Access Compliance Report Public Rights-of-Way (Curb Ramps)

Intersection ID: 23499 Main Street: ALEXANDER_RD Cross Street: BROOKFIELD_PL Location: NW **Overall Compliance: No Severity Score:** ADA ID: D6C71246E328 Ramp Type: Directional1 Initial Pass/Fail: Fail 12.5

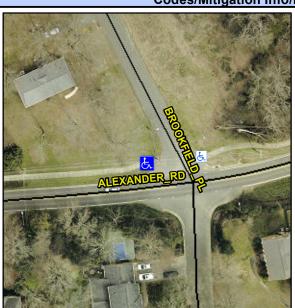
Field Measurements/Component Compliance						
Compliance Description		Data	Compliance Description		Data	
N/A	Ramp Length (in)	48.0	N/A	Grade Break?	N/A	
Yes	Ramp Width (in)	64.0	N/A	Grade Break Slope (%)	0.0	
Yes	Ramp Slope (%)	2.2	N/A	Grade Break XSlope (%)	0.0	
No	Ramp XSlope (%)	6.3				
N/A	Flare Type LT	N/A	N/A	Flare Type RT	N/A	
N/A	Flare Slope LT (%)	N/A	N/A	Flare Slope RT (%)	0.0	
N/A	Flare Traversable LT?	N/A	N/A	Flare Traversable RT?	N/A	
N/A	Landing Length (in)	0.0	N/A	DWS Provided?	N/A	
N/A	Landing Width (in)	0.0	N/A	DWS Contrast?	N/A	
N/A	Landing Slope (%)	0.0	N/A	DWS Length (in)	N/A	
N/A	Landing X Slope (%)	0.0	N/A	DWS Full Width?	N/A	
N/A	Landing Curb? (Y/N)	N/A	N/A	DWS Offset LT (in)	N/A	
N/A	Shared Landing?	N/A	N/A	DWS Offset RT (in)	N/A	
N/A	Gutter Ponding?	0.0	N/A	Gutter Slope (%)	N/A	
N/A	Gutter Lip Ht (in)	0.0	N/A	Gutter X Slope (%)	N/A	
N/A	Painted X Walk1?	No		Road Slope (%)	0.4	
	X Walk 1 Direction	To E		Road X Slope (%)	2.5

Possible Solutions: Remove & Replace Entire Ramp. Surveyor Notes: N/A PROW/ADA: R304.5.3
